CHIQUITA CANYON SANITARY LANDFILL

COMPLIANCE ORDER PERTAINING TO 27

DATE: May 1, 2025

Figure 6. Gas Wellheads exceeding temperatures over 170°F and CO over 1,500 ppmv at the Chiquita Canyon Landfill, July 2023.

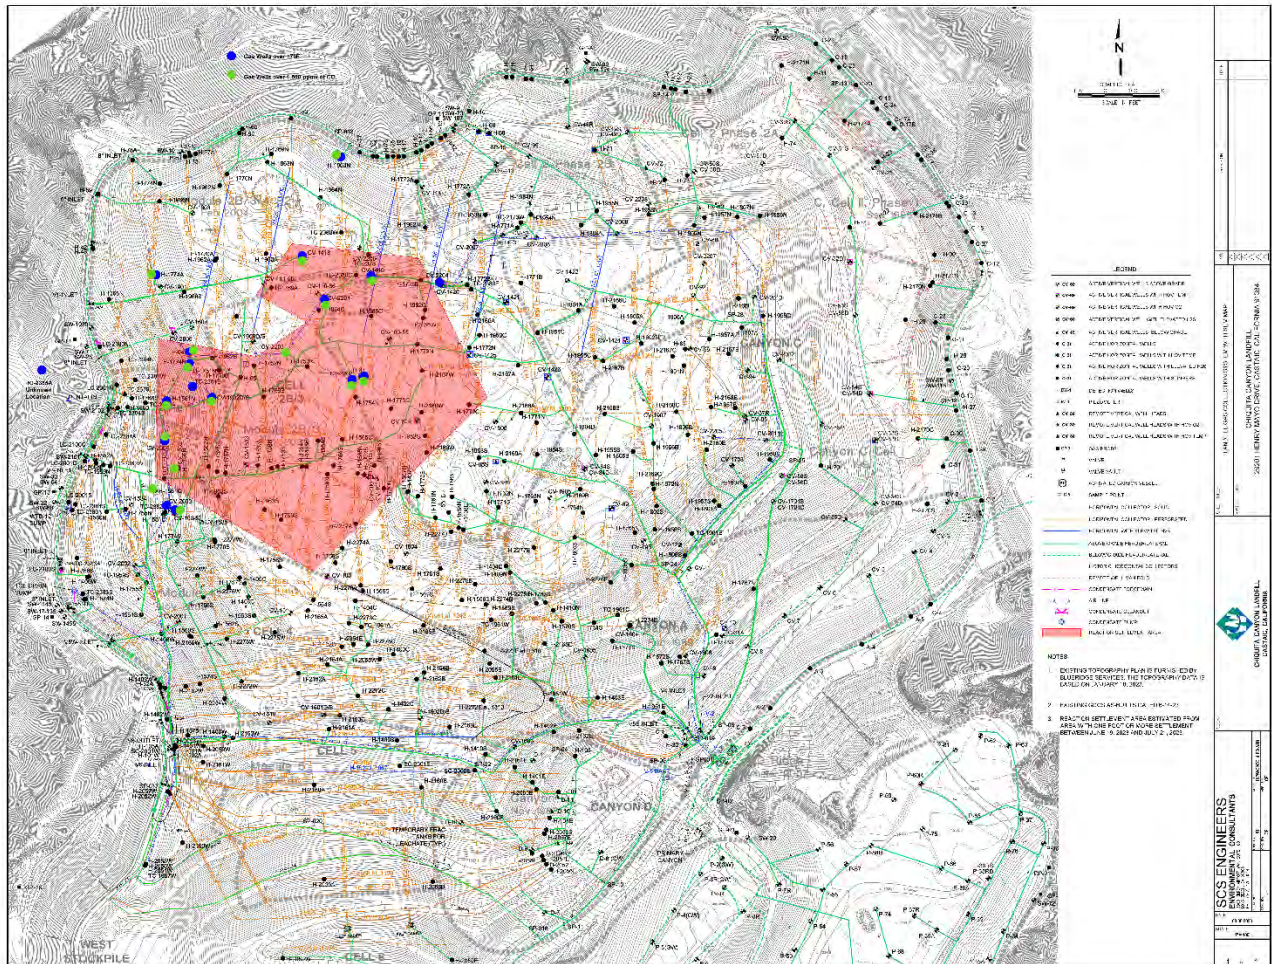
Using the previously discussed criteria, a map of the heating/smoldering event as of

July 2023 is shown in Figure 6. Wells with CO above 1,500 ppm (indicated by a green circle) and temperatures over 170°F (indicated by a blue circle) were plotted on the CCL's Reaction Settlement Area Map. Circles that share a boundary indicate the well has high CO and temperature.

Figure 3. Temperature Spike at TMP-10 as Measured at 30 Feet from July 26 to September 12, 2024.

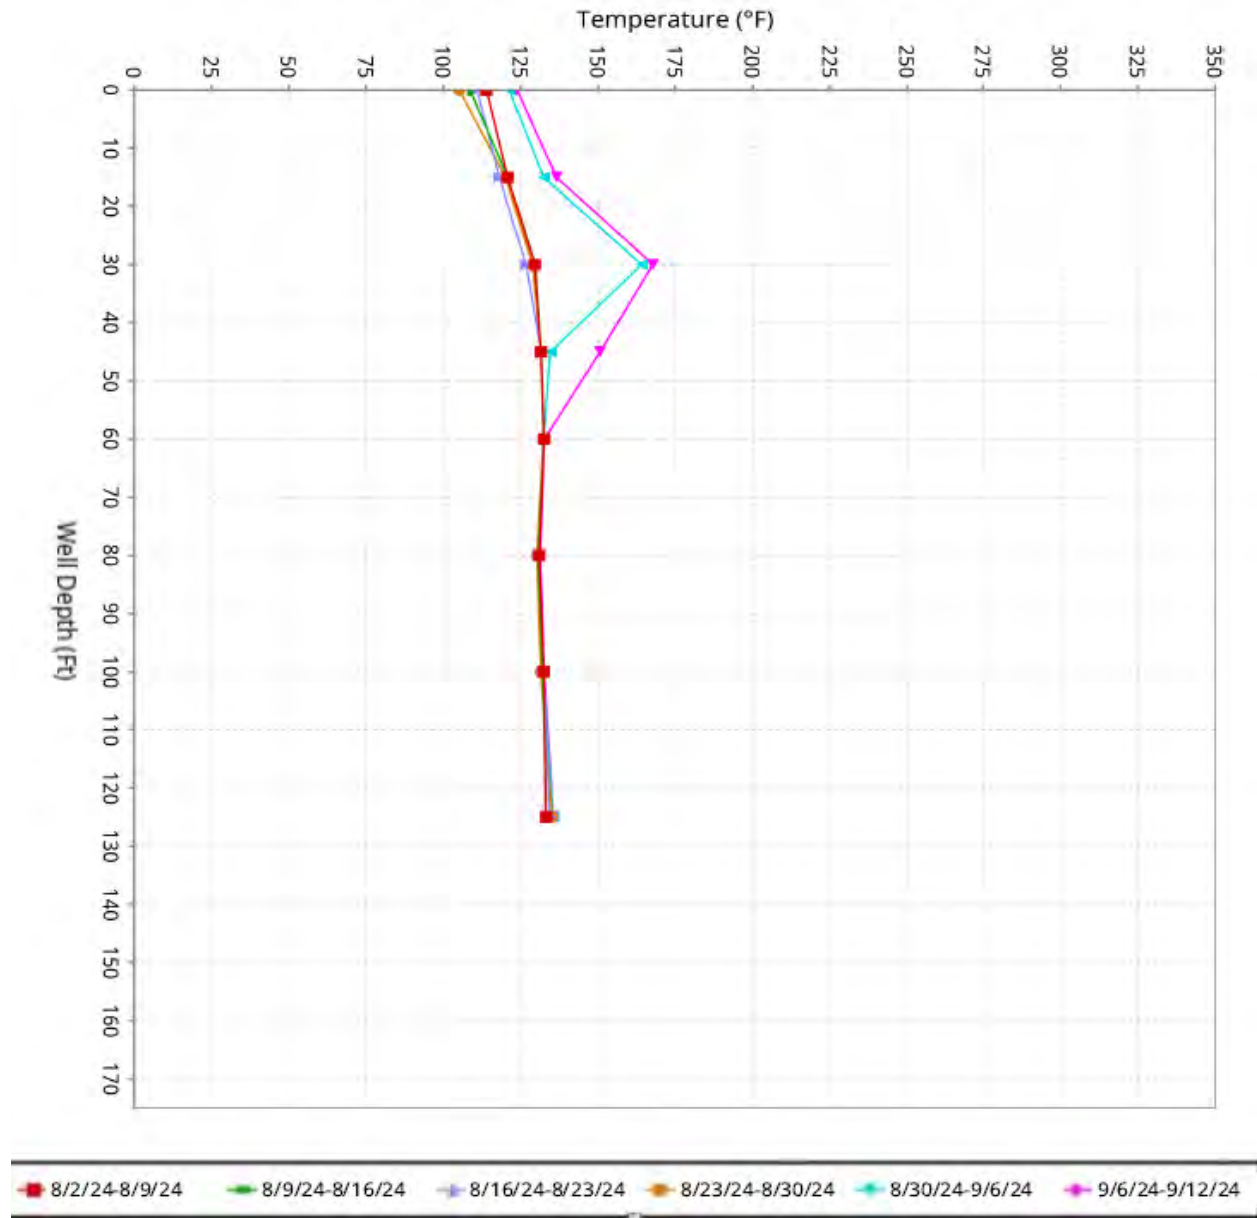
- TMP-10 increased by 19.8°F within 48 hours from August 30 to September 5, 2024, and 41.6°F in 14 days from 126.1°F to 167.7°F from August 25 to September 8, 2024.
- TMP-13, TMP-15, and TMP-17 also show temperature spikes of 20°F to 25°F during the week of August 16 to August 22, 2024. The most significant temperature spike was from TMP-15, where the temperature rose 33.4°F in one day from September 5 to September 6, 2024, at the 30-foot thermocouple. Figures 2 and 3 show examples of the shallow temperature spikes in TMP-13 and TMP-10, respectively.
- The CCL-identified reaction zone from the depths of 70 feet to approximately 140 feet has remained consistent since July 26, 2024.

CalRecycle recommends that the LEA accept the proposed additional TMPs listed in Appendix D, Proposed “Sentinel” Temperature Monitoring Probes and Primary & Secondary Engagement Lines. In addition, due to the recent temperature spike at TMP-10, the CCL should add one TMP at the location shown in Figure 6. This temperature probe should be the first TMP installed.

Figure 4. CCL's Temperature Probe Installation Project, Dated July 2024.

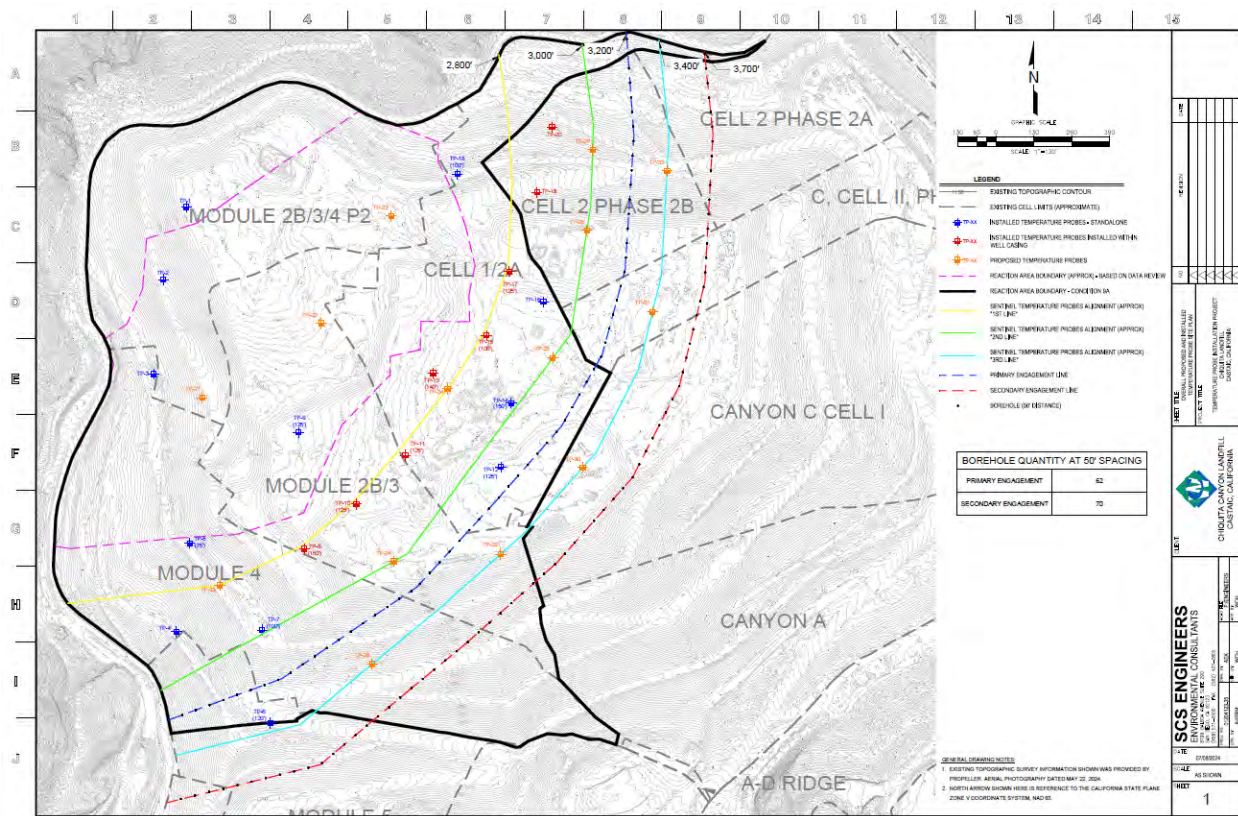
The CCL proposes to install the reaction break/barrier at the primary and/or secondary engagement lines, as shown in Figure 4, only if all the Threshold Criteria Limits shown in Exhibit 1 are exceeded at the corresponding Sentinel Monitoring Network (i.e., TMPs and associated vertical LFG extraction wells). The criteria for implementing containment strategies will be the same as determining whether the reaction is expanding with several verifications to ensure the decision to install a barrier is valid. Temperature will be the primary standard for installing a barrier, with LFG data being the secondary standard.

Figure 5. Vertical Shaft Barrier.

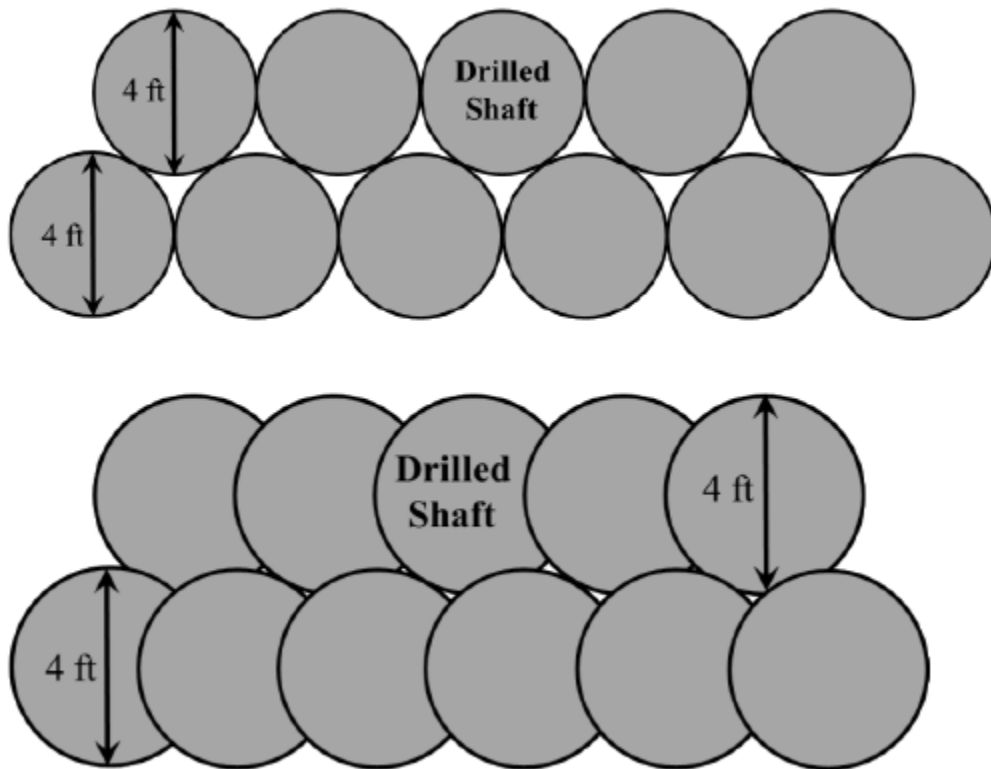
For deeper reactions, the barrier must be constructed using borehole drilling combined with flowable fill injection. If this method proves ineffective, a vertical shaft barrier should be installed using a bucket auger drill rig with a 3 to 4-foot diameter augur, drilled to a minimum depth of 50 feet or leachate liquid level, and backfilled with a cement-bentonite or soil-bentonite mixture to form a continuous barrier. See Figure 5 in the CalRecycle Letter.

Figure 1. Temperature profiles over six weeks from 1/9/2025 to 2/19/2025 from SCS report dated February 20, 2025.

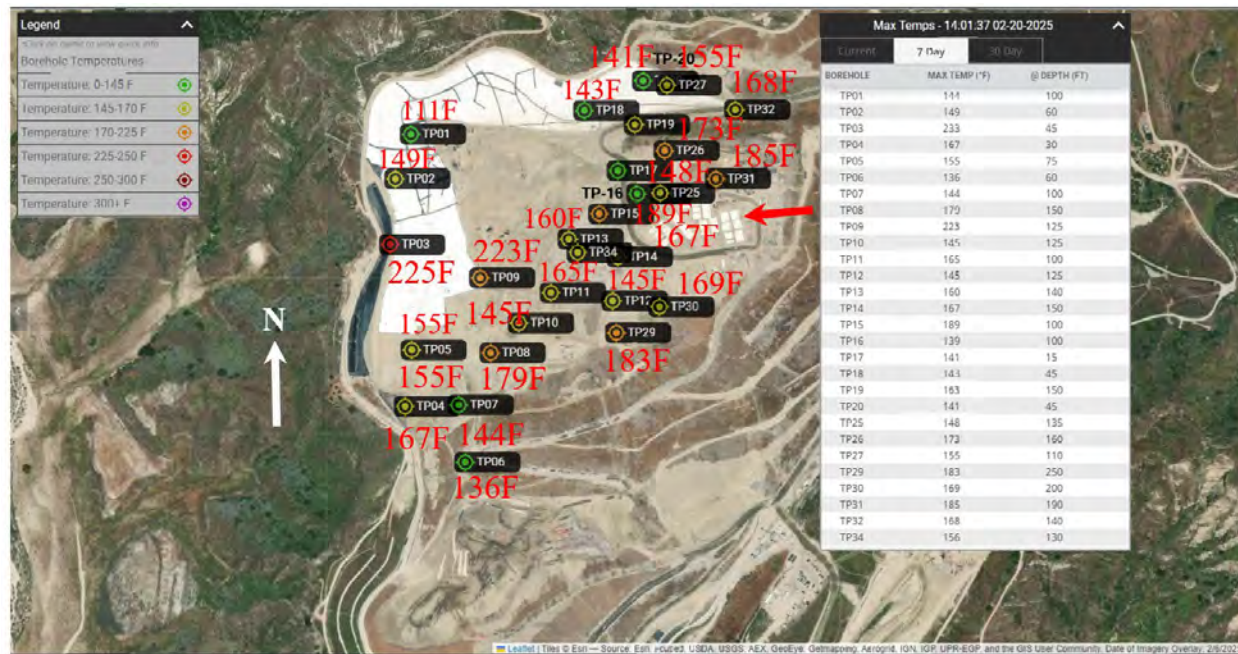
SCS presents Waste Borehole Maximum Temperature Profiles Over 6 Weeks from January 9, 2025 to February 19, 2025.⁶ An aerial image of CCL with a table of maximum temperatures is included in the subject SCS Report and reproduced in **Figure 1**. I have placed the maximum waste temperature from the table in **Figure 1** adjacent to some of the gas extraction wells to facilitate understanding the extent of the SET Event, especially on the east side of CCL. **Figure 1** shows waste temperatures of 183°F and 185°F at the eastern side of the top deck of the CCL. This means the SET Event has migrated from the western slope (TP03) to the eastern side of the CCL (TP31). Expansion of the SET Event has the following implications:

- Elevated temperatures (185°F to 189°F) surround the leachate tank farm (see red arrow in **Figure 1**). This area is going to undergo significant settlement, if it has not already started to do so, due to thermal breakdown of the buried waste. This settlement will cause differential movement of the leachate tanks, which could result in a leachate release. As a result, I recommend the leachate tank farm be moved off the top deck and to a site off the CCL and on native soil because the SET Event continues to expand.

Figure 2. Extent of elevated temperatures from March 27, 2024 to February 26, 2025.

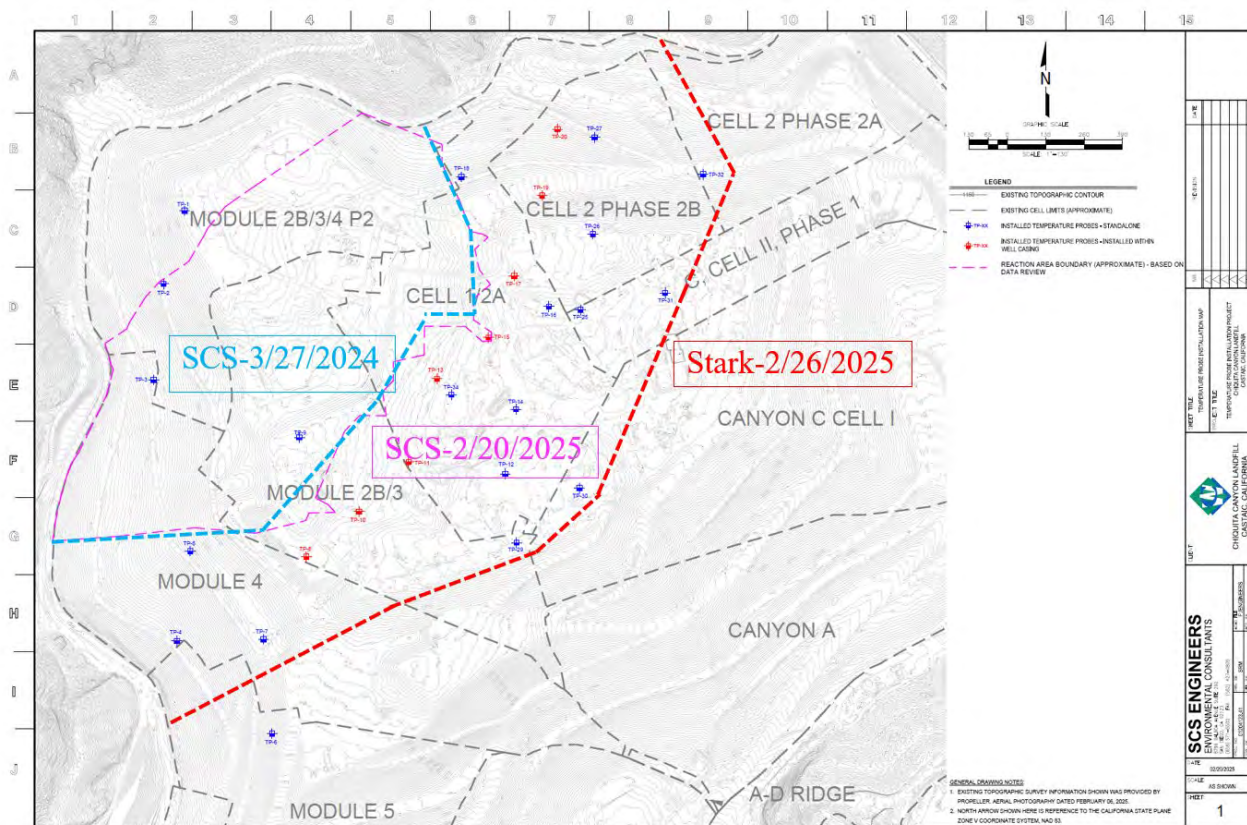
Figure 2 presents Sheet #1 from the SCS Report that presents the Waste Borehole Maximum Temperature Profiles Over 6 Weeks from January 9, 2025 to February 19, 2025.⁷ The dashed pink line represents the extent of the SET Event as determined by SCS on February 20, 2025. This extent is slightly larger than the dashed blue line, which represents the extent of the SET Event on March 27, 2024 as reported by SCS in the initial Soil Reaction Break/Barrier Plan.⁸ **Figure 2** also presents my extent of the SET Event as of February 26, 2025 (see dashed red line) based on the Waste Borehole Maximum Temperature Profiles Over 6 Weeks from January 9, 2025 to February 19, 2025.⁹ **Figure 2** shows the western slope and entire top deck of the CCL is now part of the

SET Event, which is a significant increase over the extent reported by SCS on March 27, 2024¹⁰ and February 20, 2025.¹¹ Based on **Figure 2**, SCS believes the SET Event only covers about 28 acres as of February 20, 2025 whereas my extent of the SET Event covers about 90 acres.

Figure 7. Extent of elevated temperatures on February 26, 2025 and location of a possible vertical barrier to isolate southernmost 13 acres.

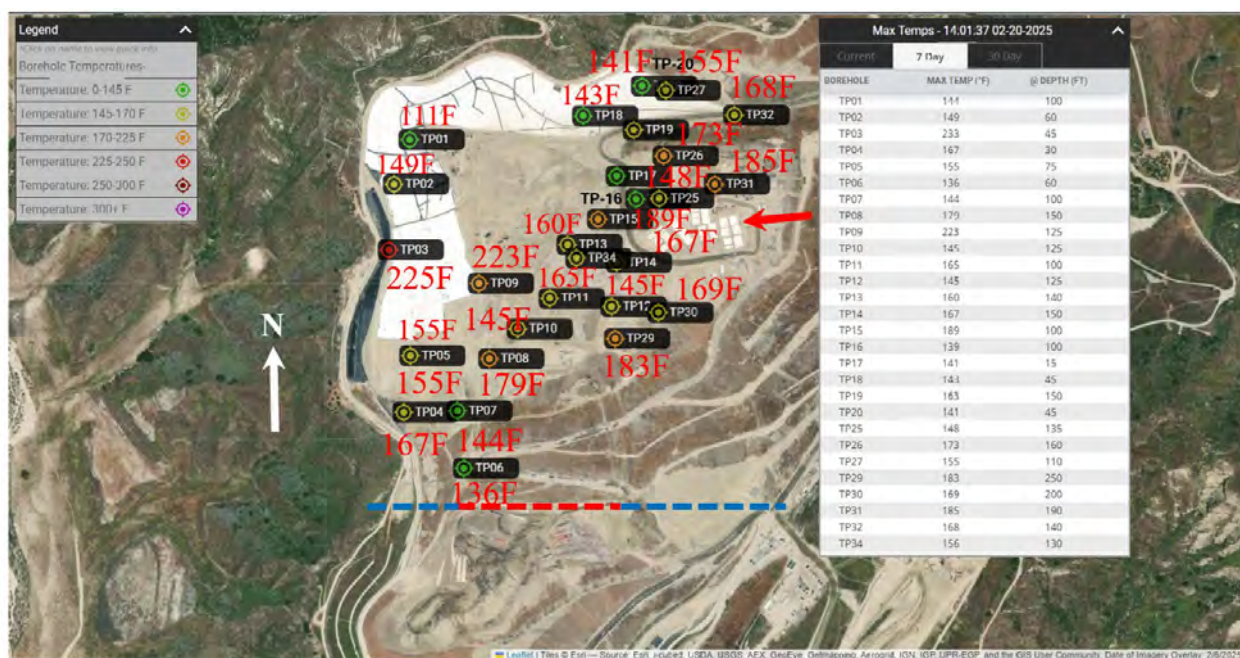
This section discusses installing a thermal barrier south of TP06 (see dashed red and blue line in **Figure 7**). A thermal barrier is recommended along the dashed red and blue line in **Figure 7** for at least the following reasons:

- CCL is using the approximately 13 acres south of the dashed red and blue line in **Figure 7** for disposal operations so elevated temperatures should be prevented from reaching this area, so the landfill continues to have an area to dispose of on-site wastes.
- Ensure continued ingress and egress from the CCL.
- Reduce the amount of waste that can be consumed by the SET Event and thus reduce the duration of odors and emissions to the surrounding communities.
- Maintain stability of the southern sideslope.

The red dashed line in **Figure 7** roughly delineates the location of a thermal barrier already constructed by CCL. The extent and depth of the thermal barrier are not known, so I request this information be provided by CCL. The blue dashed lines in **Figure 7** indicate the existing thermal barrier should be extended east and west so the SET Event cannot go around or under the existing thermal barrier.

If the existing thermal barrier does not extend to near below the leachate level, vertical elements can be used to create a vertical thermal barrier to prevent the SET Event from impacting the southernmost 13 acres of the CCL. The vertical elements involve excavating a vertical shaft using a three or four-foot bucket auger drill rig, which is being used to install gas extraction wells at CCL. These vertical elements would be constructed along the dashed red and blue lines in **Figure 7**. After excavating the shaft, it could be backfilled with a soil-bentonite or soil-cement mix. The shafts would be tangent, i.e., touching, or overlapped (see **Figure 7**) to create a continuous barrier across the toe of the southern sideslope to prevent the SET Event from consuming the southernmost 13 acres. If heat transfer calculations require a wider thermal barrier, a second row of vertical elements could be constructed north or south of the initial row (see **Figure 7**). The secondary row would be tangent to the initial row and be centered at each intersection of the initial row as shown below (see **Figure 7**).

5. Submit a Request For Information (RFI) regarding the current extent and depth of the thermal barrier installed near the southern end of the CCL (see red dashed line in **Figure 7**), and

Figure 2. TMP-14 Temperature Profile Demonstrating a Shallow SET Event Developing at Chiquita Canyon, April 24, 2024, to March 19, 2025. (Source: SCS Engineers TMP Data)

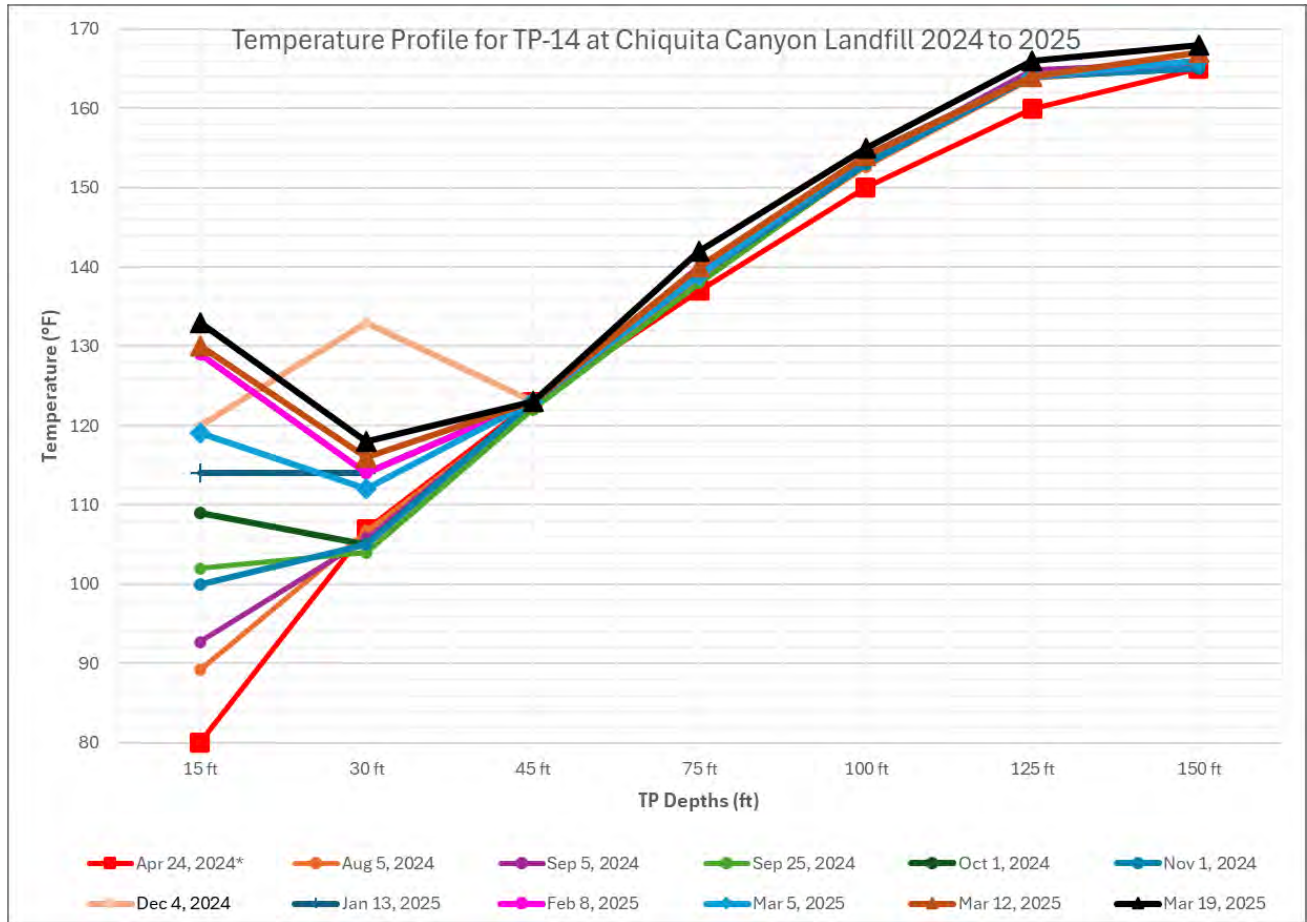
As an example of how wellhead temperatures can mask what is occurring in the waste, as shown in **Figure 2**, TMP-14 reported a temperature of 80°F (26.7 °C) on April 24, 2024, at the fifteen-foot probe. By March 19, 2025, the temperature at the 15-foot probe had increased to 133°F (56°C). This shallow temperature spike was not observed in gas well CV-1906, approximately 10 to 15 feet away, where the wellhead temperature was reported to be 68°F (20°C) on April 1, 2024, and 60°F (15.5°C) on March 19, 2025. There were also significant temperature swings in the wellhead temperature data for gas well CV-1906, where the temperature rose from 95°F (35°C) to 121°F (49°C) and then dropped to 73°F (22.7°C) within a month. However, all the wellhead temperatures are below the regulatory threshold and do not require further analysis. Data from TMP-14 indicated that on March 19, 2025, the temperature reached 133°F (56°C) and exceeded the 131°F (55 °C) threshold. CV-1906 is also experiencing a significant oxygen overdraw at this location. The percent oxygen has varied from 10.9 percent on March 4, 2024, to 18.7 percent on March 6, 2025. The average oxygen for the past year at this well is 8.4 percent. Continued high oxygen levels above 2 percent and temperature spikes will lead to a SET Event. This TMP and gas well are approximately 450 feet away from the CCL-defined reaction boundary and CalRecycle staff do not believe the shallow temperature increases are connected to the main reaction area. CalRecycle believes that the temperatures of 166 to 168°F (74.4 to 75.5°C) at the deeper probe (i.e., 125 to 150 ft) are connected. However, this data demonstrates that the operation of the GCCS must not sacrifice LFG operational objectives/standard operating procedures (i.e., limiting oxygen to 2 percent¹⁵) to control emissions and risk developing of new SET Events. **Table 2** and **Table 3** provide the LFG data and temperatures for gas well CV-1906 and TMP-14.
